PROPOSED PUBLIC PATHWAY 21, 23 & 25 NORTH AVALON ROAD – AVALON BEACH ARBORICULTURAL ASSESSMENT REPORT

File No: RTC-16219

Figure 2, showing typical footpath cross section

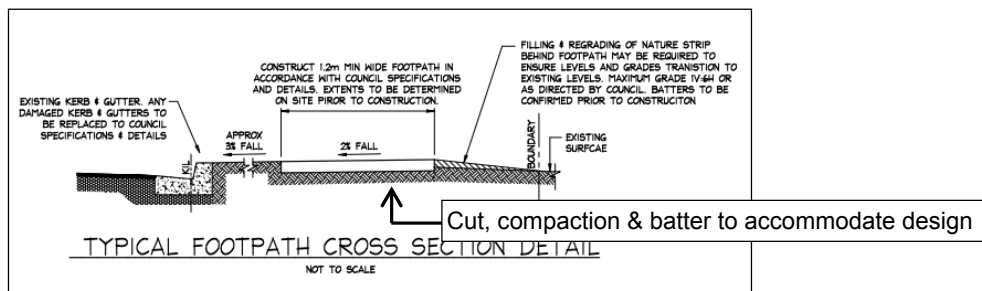
2. The proposal is to construct a 1.2m wide public footpath central to the Council verge, constructed to Council specifications and details. The typical cross section detail plan shows excavation with potential regrading and batter to ensure levels and grades transition to existing levels.

4. Based on the design footprint it is highly likely tree 3 will require removal unless tree sensitive design techniques are adopted to retain the tree.

5. Tree sensitive design techniques identified within AS4970-2009 and to consider for this proposal are:
 - Suspending the footpath to span over the SRZ without disruption to underlying tree roots by pier & beam construction

- Constructing the pathway on top of a ground level, on a permeable subbase without grading cut or compaction within the SRZ
 - Install alternative permeable / porous pavement materials such as soft fall rubber, asphalt or permeable paving that does not require grading cut or compaction
